SX-16 Searchlight Cooling Enhancements Safety and Service Bulletin # SL 0214

Subject: SX-16 Searchlight Cooling Enhancements**Affected Products:****All SX-16 Nightsun® Searchlights with existing rubber baffling on the Front Window and standard Cooling Blower airflow direction**

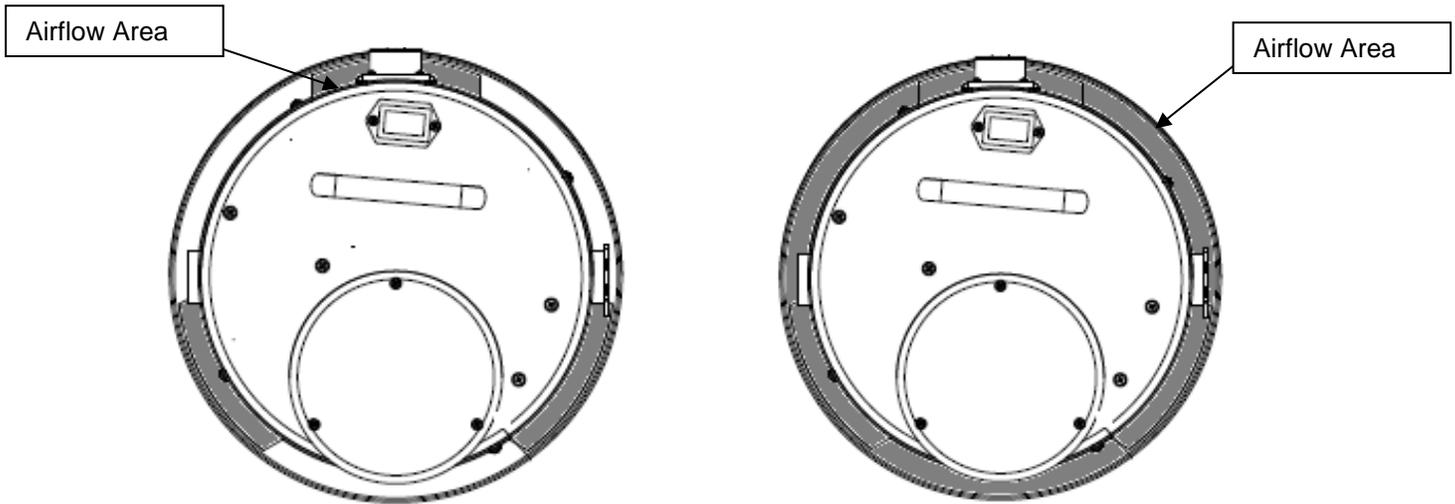
Previously, the air to cool the Lamp entered the rear of the Searchlight and exhausted the heat generated by the Lamp and other internal components through the Front Window Baffle (left below). This was achieved by the original rotation direction of the Cooling Blower. By reversing the air flow direction, the air now enters through the Searchlight Front Window Baffle and the heat is exhausted through the Cooling Blower Cover on the Rear Cover of the Searchlight (right below). This update as well as the Front Window Baffle material change described in the next paragraph, contributes to improved cooling.

The standard Baffle bonded to the Front Window is made of heavy rubber which allows air to flow through three openings. This Baffle is recommended to be changed to a filter foam type Baffle to allow air to flow uniformly throughout the entire perimeter of the Front Window. The illustration below compares the rubber Baffle (left) to the filter foam type Baffle (right) looking at the rear of the Searchlight with the shaded areas where air can flow. The figure on the right shows that air will flow evenly around the Searchlight as opposed to three vent areas.

In addition to allowing more airflow, another feature of the foam baffle is that it prevents particles such as dirt, sand, insects and other types of debris from entering the Searchlight.

Foam Baffle applied to Front Window Lip Edge

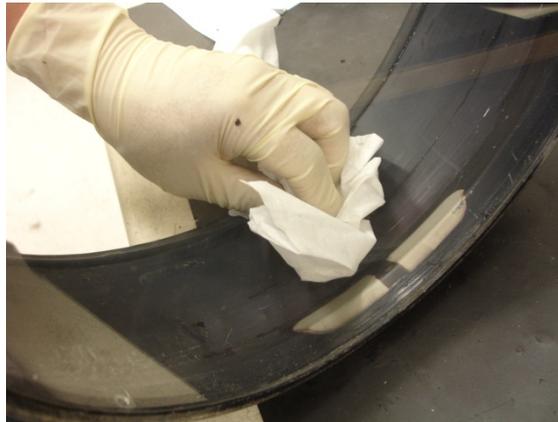
3. Apply foam baffle (P/N 034678) to the Front Window:
 - Remove paper strip to expose the adhesive side of foam baffle.

- Apply adhesive side of foam baffle around the inside of the Front Window directly under lip edge.

Cooling Blower Mounting Plate with Notch

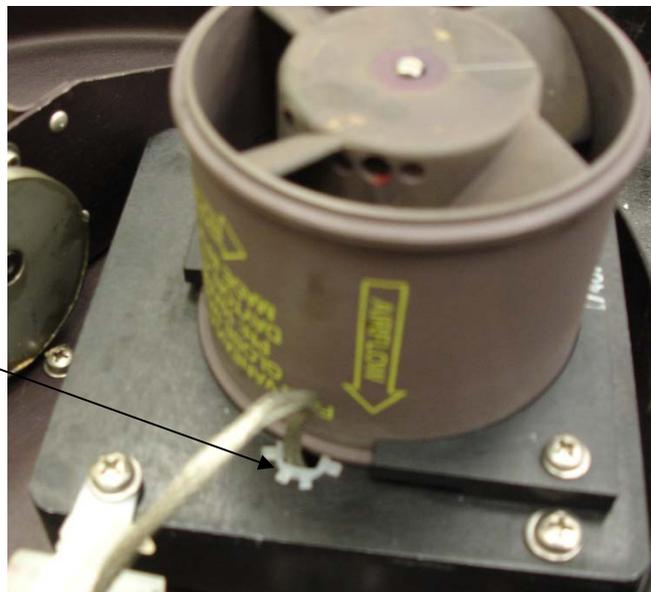
- The Cooling Blower Mounting Plate (P/N 017487) needs to be replaced with a revised part that has a notch to allow for the harness to pass through when the Cooling Blower is remounted in the reversed direction.

- Install the Cooling Blower in the opposite direction of the original orientation with the harness passing through the notch in the Cooling Blower Mounting Plate. Verify the notch is aligned with the plastic grommet then tighten mounting brackets to secure the Cooling Blower firmly to the Mounting Plate.
